Access Compliance Report

Public Rights-of-Way

(Curb Ramps)

Intersection ID: 16535	Main Street: ELDER_AV	Cross Street: ROSS_MOORE_AV	Location: E
ADA ID: 1A0375EBA9C9	Ramp Type: BlendTrans1	Initial Pass/Fail: Fail	Overall Compliance: No
		Severity Score: 35

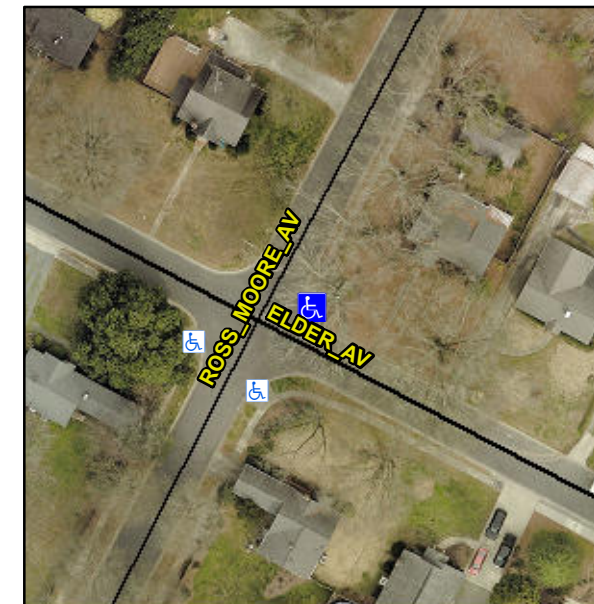
Surveyor Notes:

NO RT SW

PROW/ADA:

Not Found, R304.5.1

Possible Solutions:

Remove & Replace Curb Ramp With Two New Directional Ramps or Equivalent.
